HKS PROJECT NUMBER
16246.000

ISSUE
CCD-049

SHEET TITLE
ROOF PLAN

SHEET TITLE
**ENLARGED
FACADE
ELEVATIONS**

SHEET TITLE
SNOW CATCHMENT BASIN - QUAD D

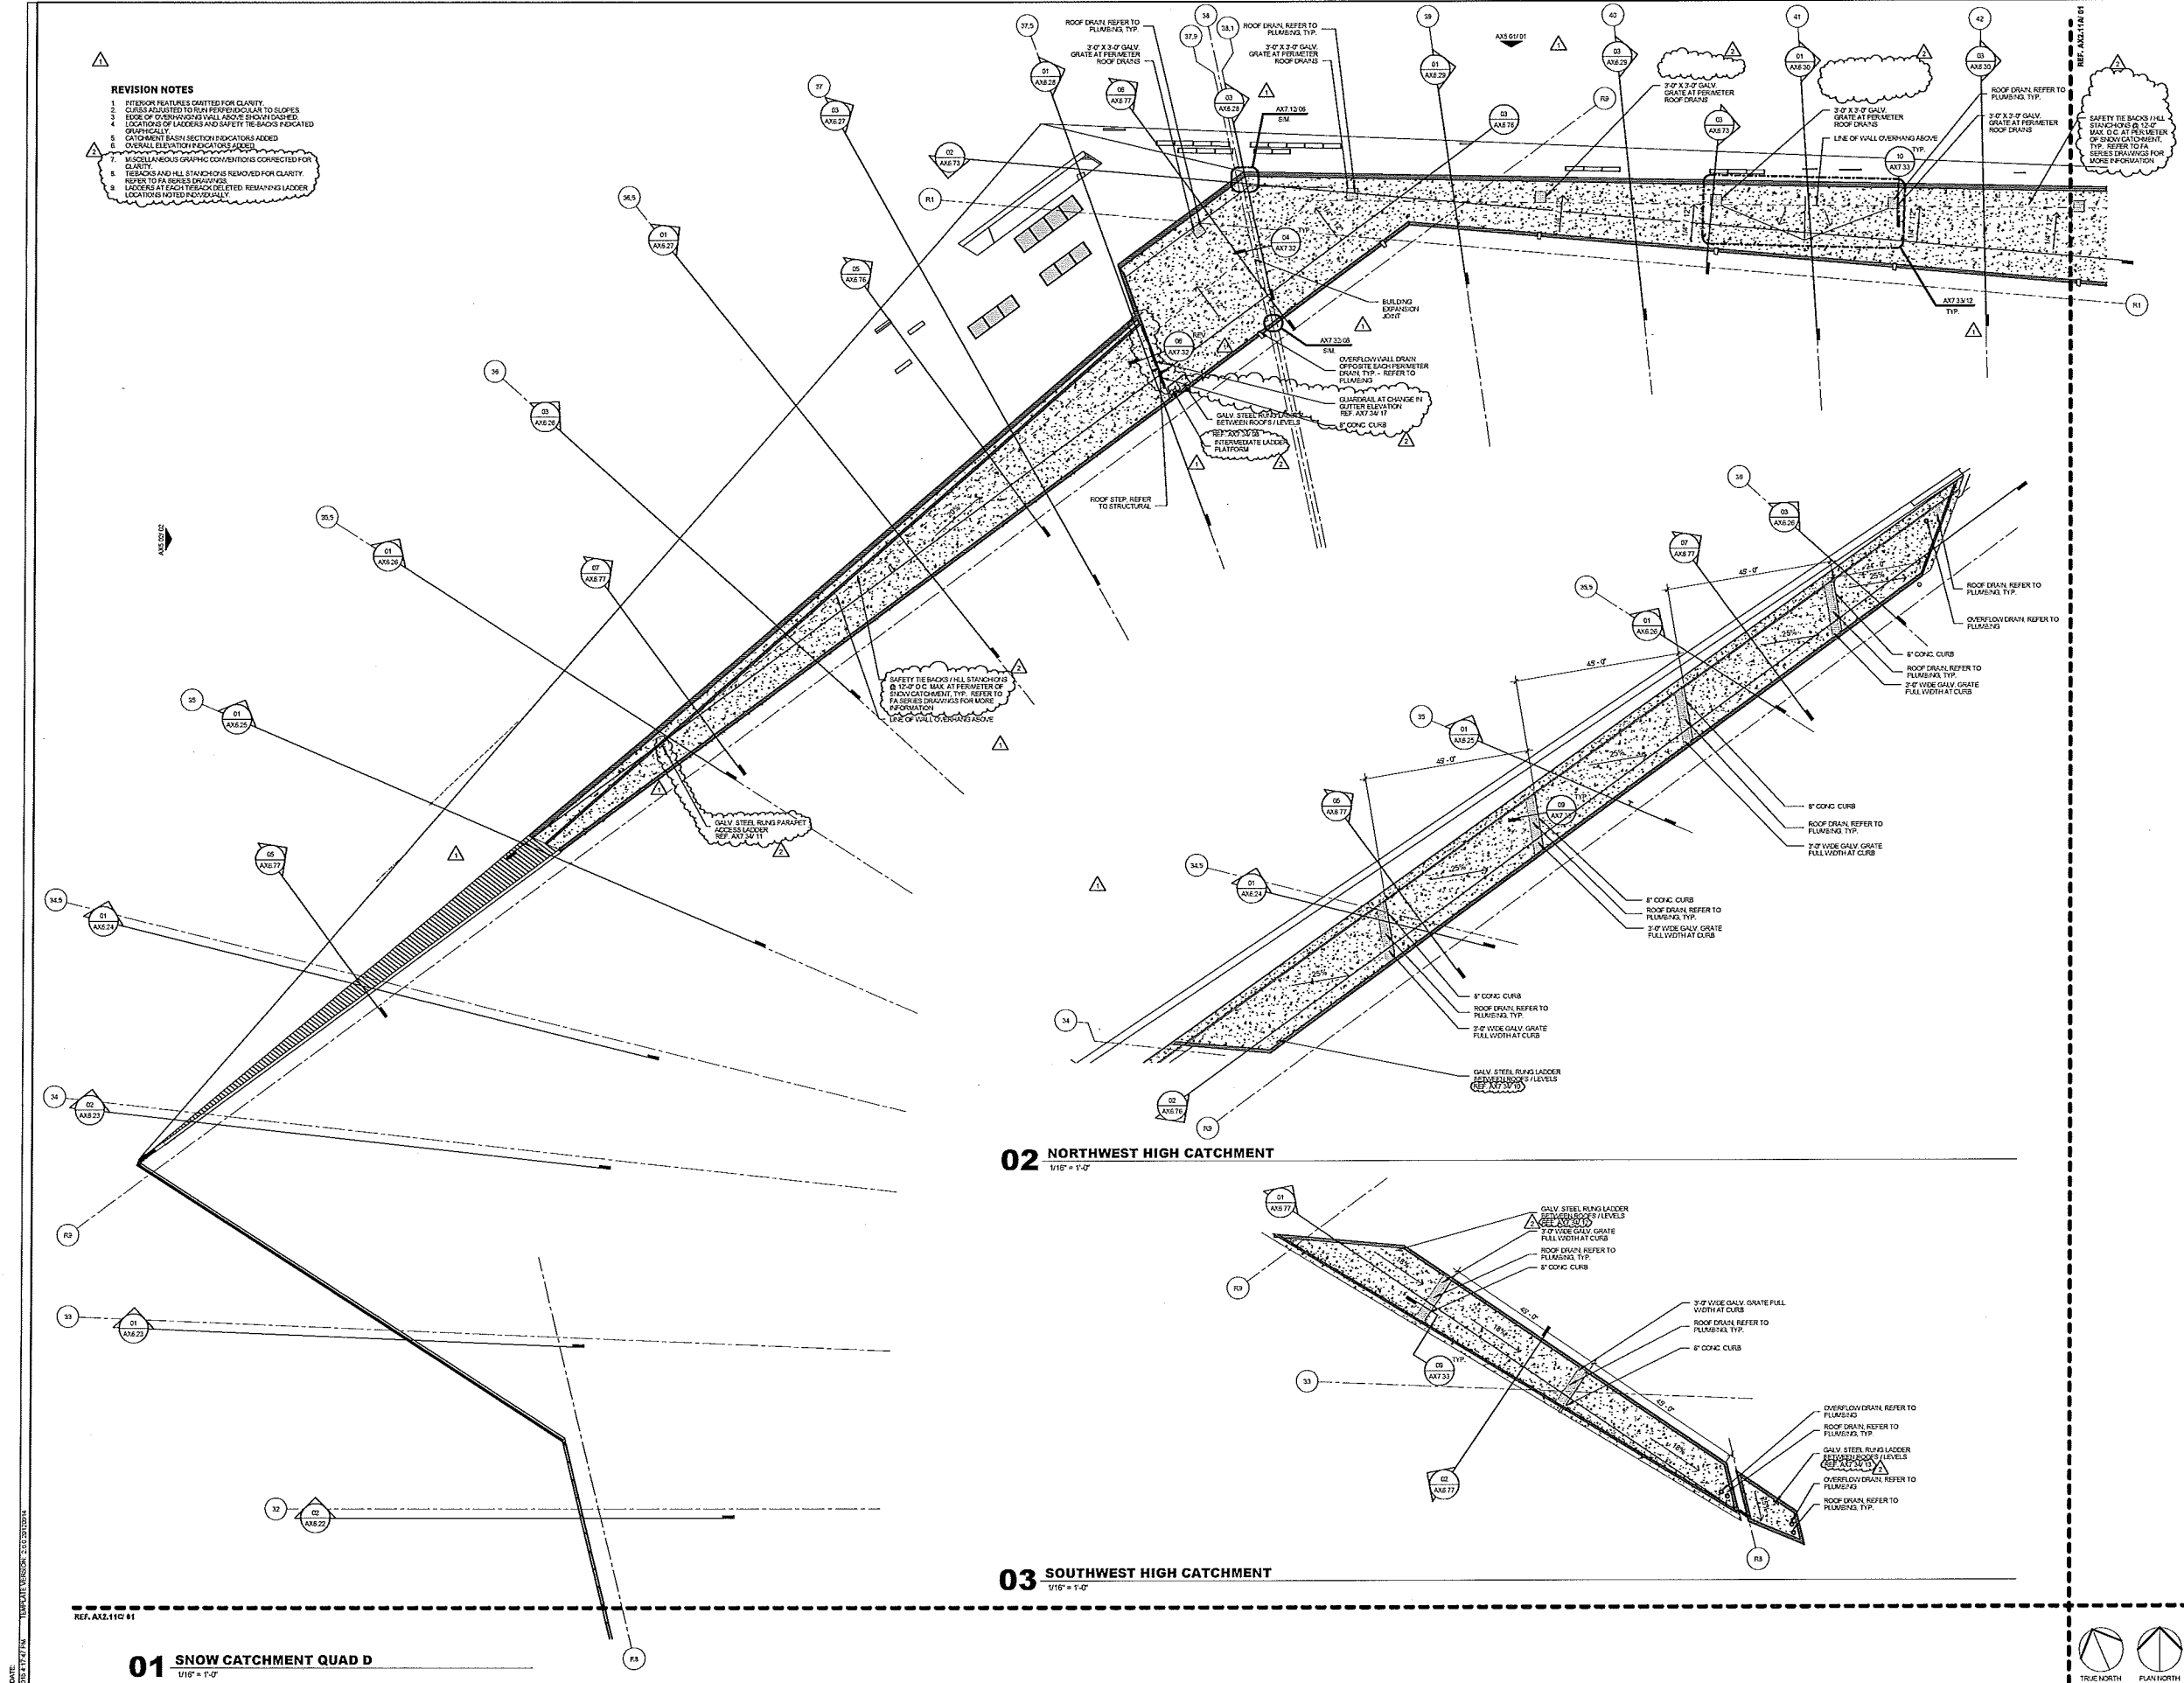
- REVISION NOTES**
1. EXTERIOR FEATURES OMITTED FOR CLARITY
 2. CURBS ADJUSTED TO BE PERPENDICULAR TO SLOPES
 3. ROOF OF OVERFLOW DRAIN ABOVE SNOW DRAIN
 4. LOCATIONS OF LADDERS AND SAFETY TIERS BACKS INDICATED
 5. OVERFLOW DRAIN INDICATORS ADDED
 6. OVERFLOW DRAIN INDICATORS ADDED
 7. TERMINI AND HILL STANCHIONS REMOVED FOR CLARITY
 8. REFER TO FAÇADE ENVELOPE DRAWINGS FOR SAFETY TIERS BACKS
 9. LADDERS AT EACH TIER AND DETECTED REMAINING LADDER LOCATIONS NOTED INDIVIDUALLY

SHEET NO.
AX2.12A

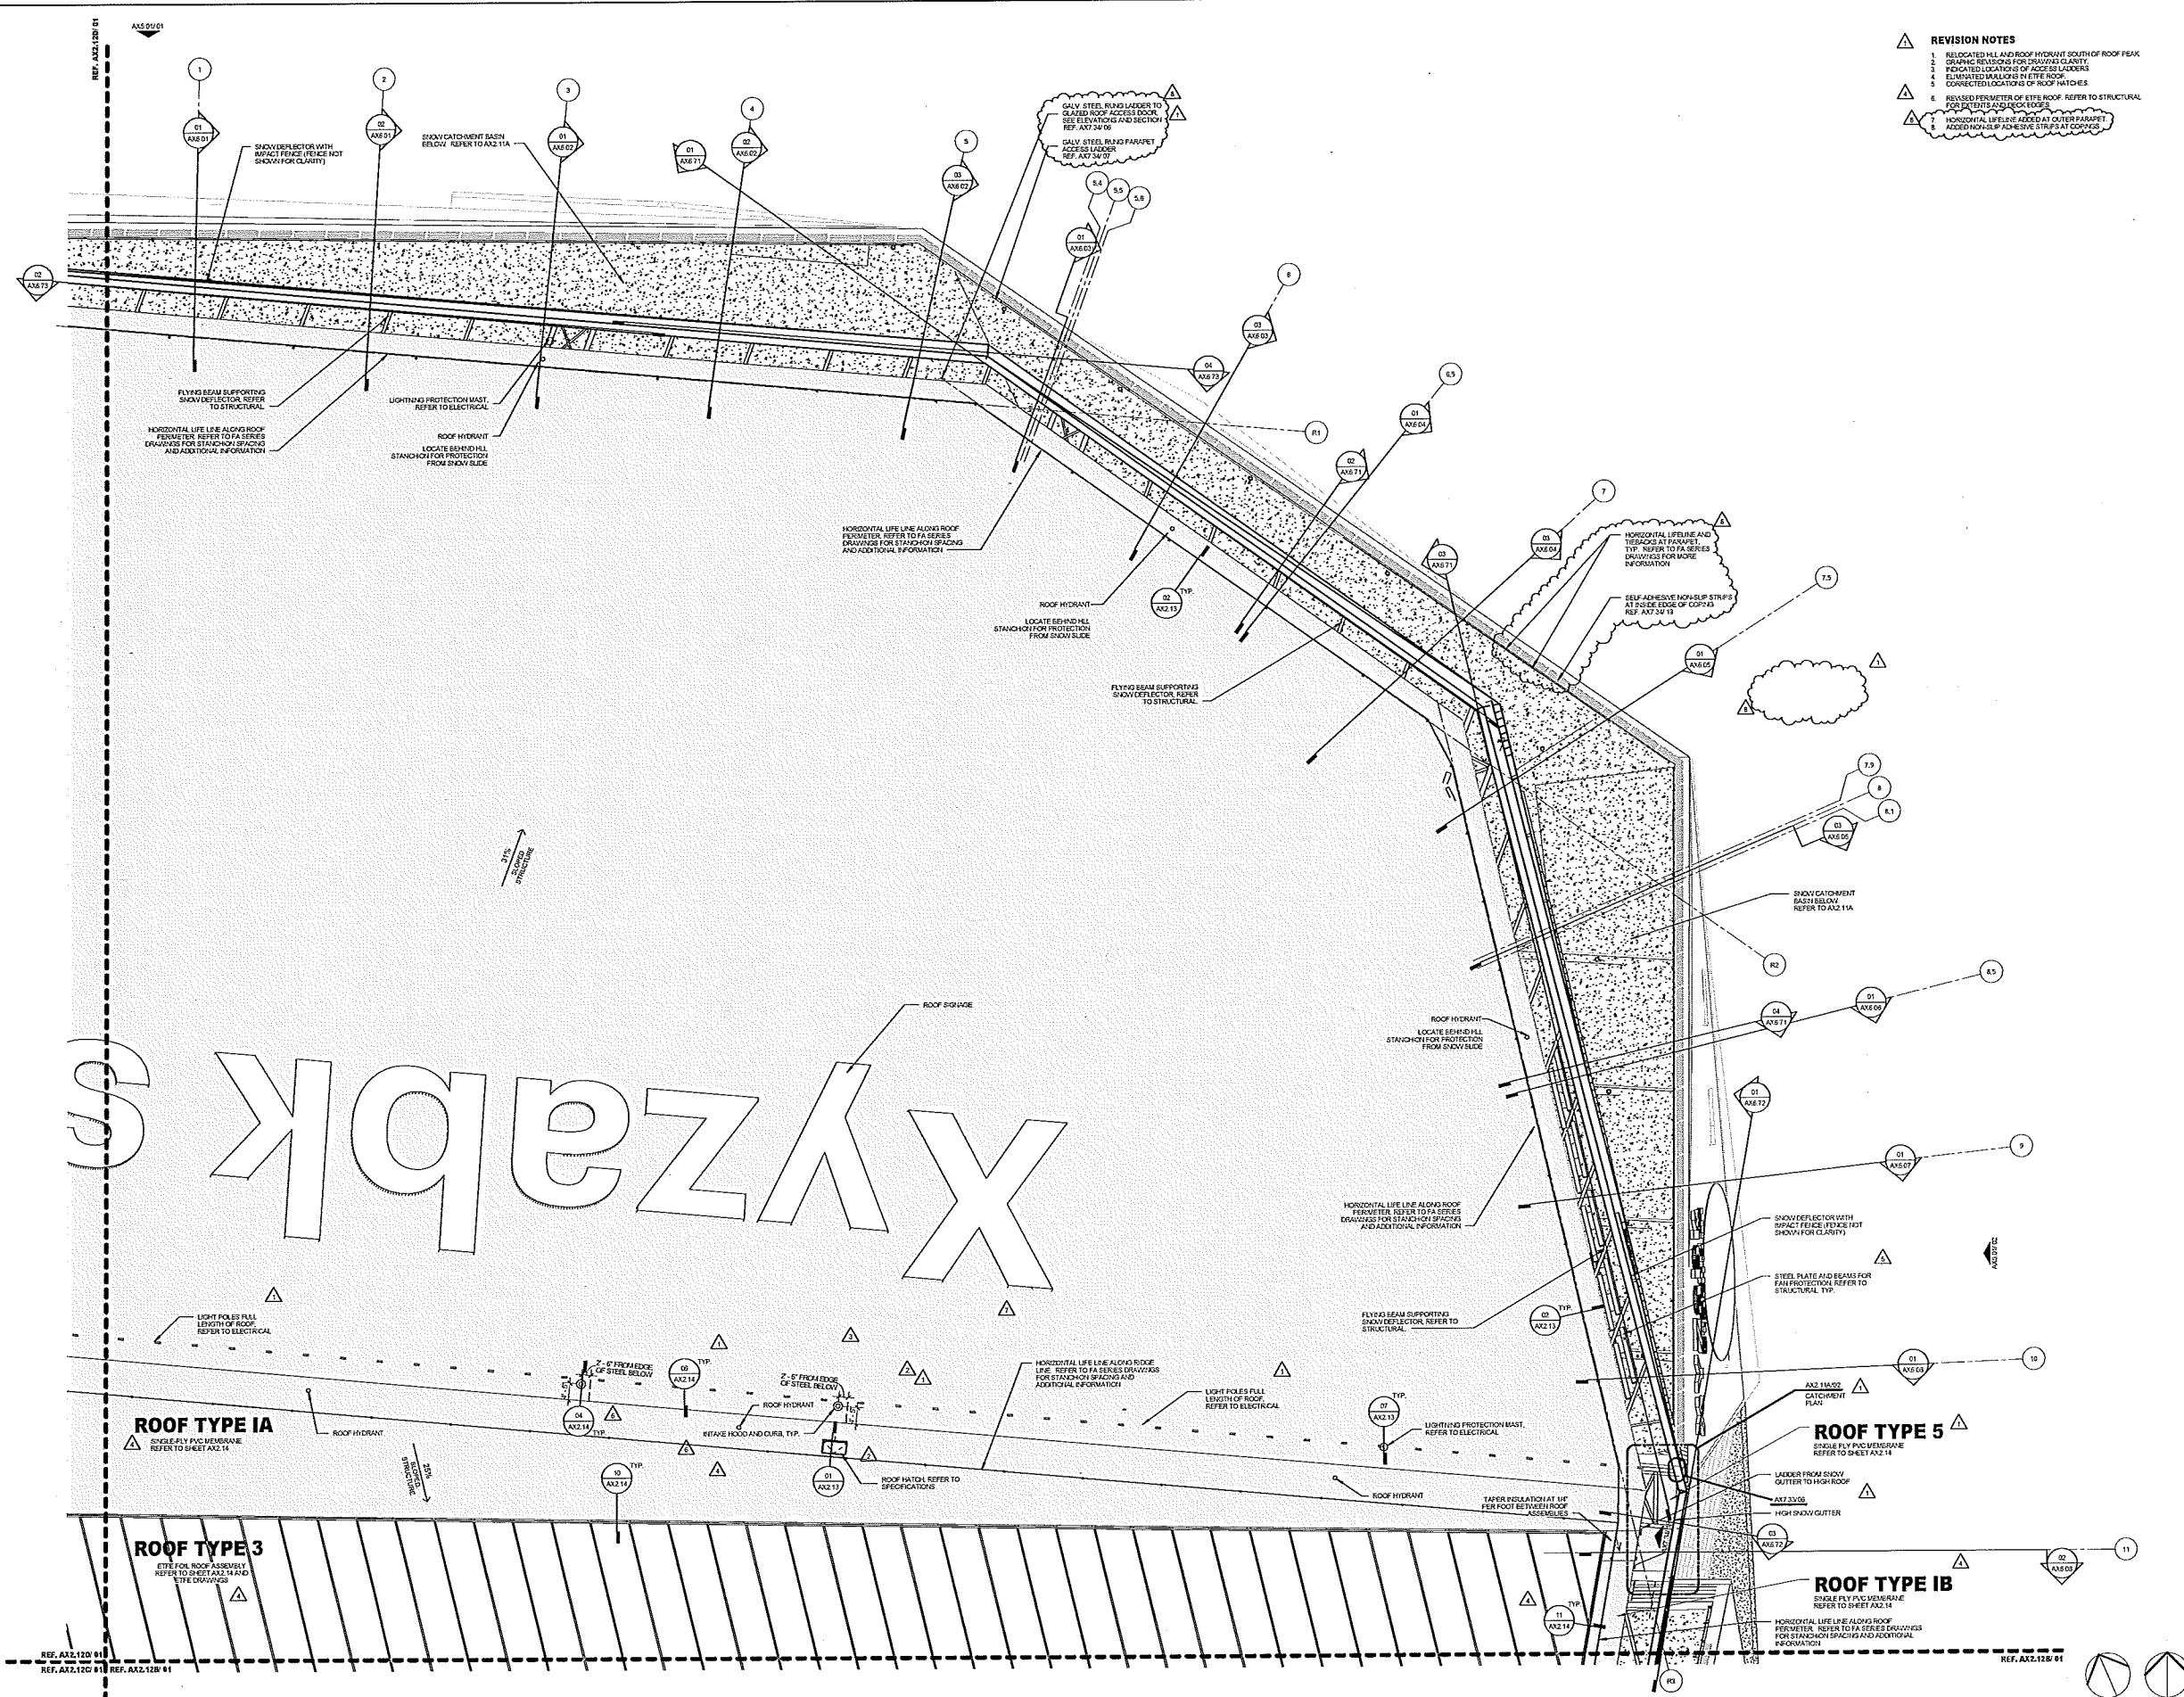
- REVISION NOTES**
1. RELOCATED HLL AND ROOF HYDRANT SOUTH OF ROOF PEAK
 2. GRAPHIC REVISIONS FOR DRAWING CLARITY
 3. FOCUSED LOCATIONS OF ACCESS LADDERS
 4. ELIMINATED WALLS IN ETRE ROOF
 5. CONNECTED LOCATIONS OF ROOF HATCHES
 6. REVISED PERIMETER OF ETRE ROOF. REFER TO STRUCTURAL FOR DETAILS AND LOCK EDGES
 7. HORIZONTAL LIFE LINE ADDED AT OUTER PERIMETER
 8. ADDED HIGH SLIP ADHESIVE STRIPS AT CORNERS

SHEET NO.
AX2.12C

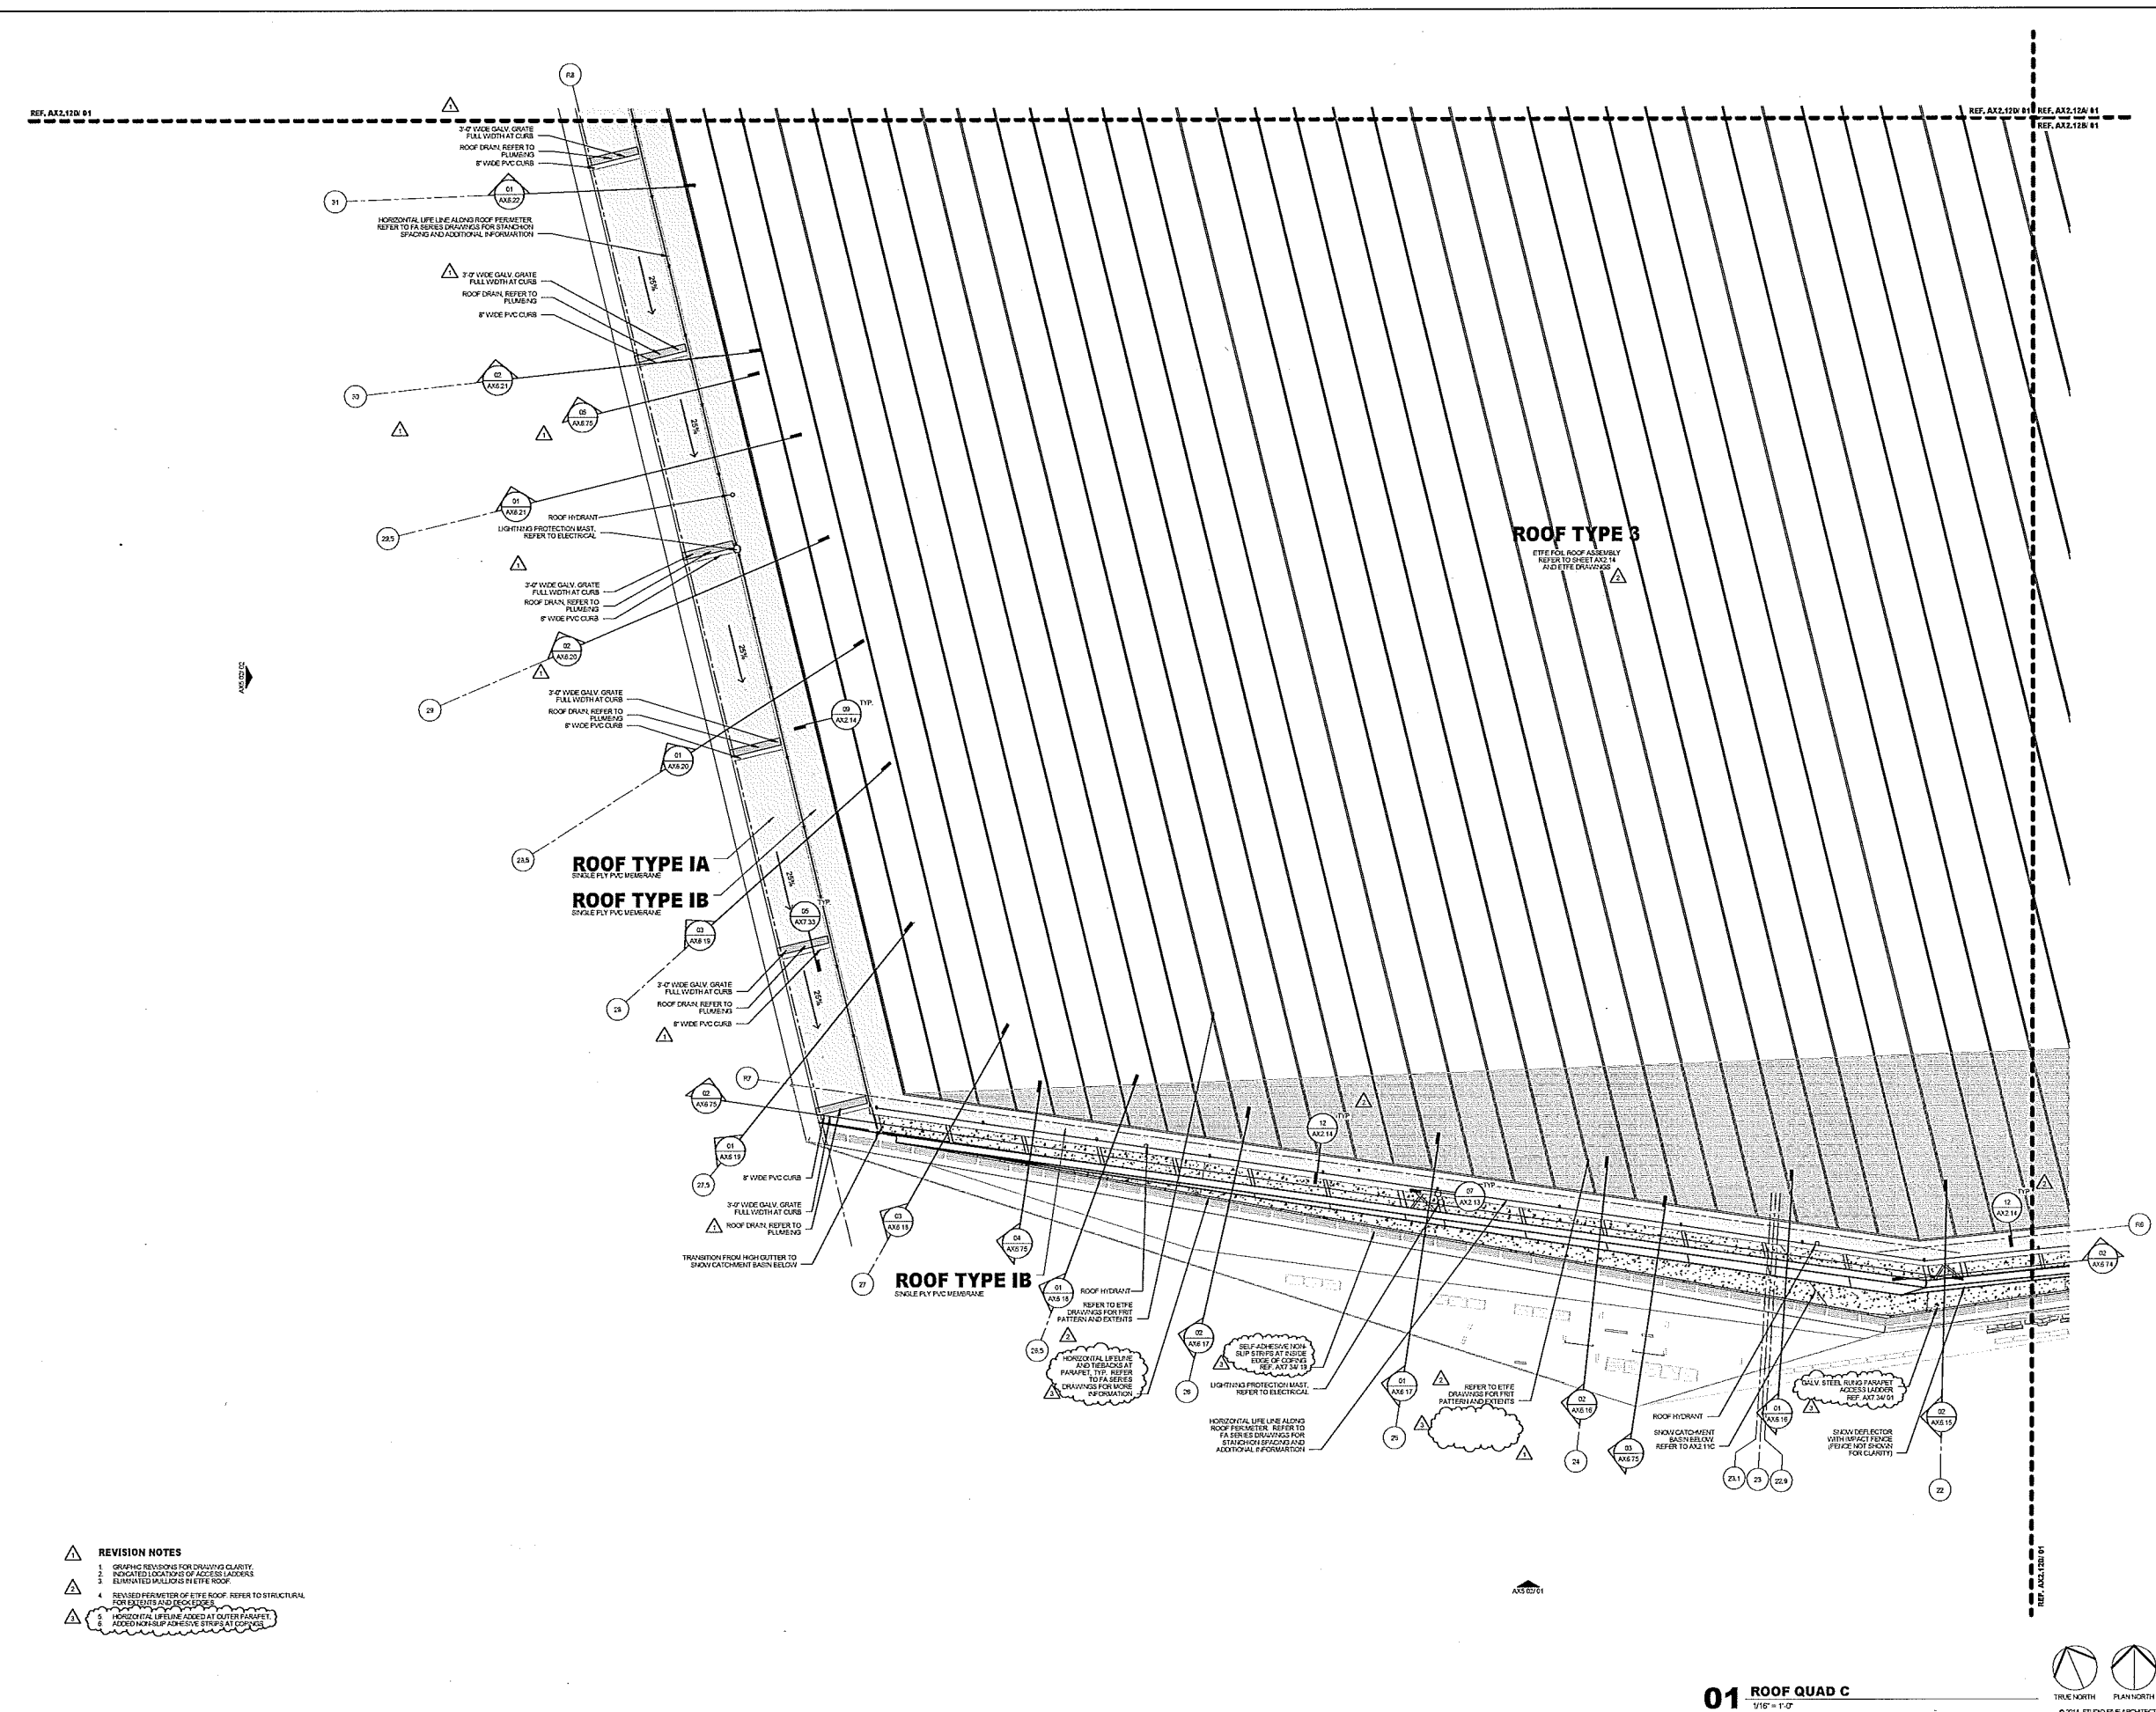
- REVISION NOTES**
- GRAPHIC REVISIONS FOR DRAWING CLARITY
 - INDICATED LOCATION OF ACCESS LADDERS
 - ELIMINATED WALLINGS BY THE ROOF
 - REVISED PERIMETER OF THE ROOF. REFER TO STRUCTURAL FOR EXTENTS AND REVISIONS
 - HORIZONTAL LIFE LINE ADDED AT OUTER PERIMETER. ADDITIONAL ADHESIVE STRIPS AT CURBS
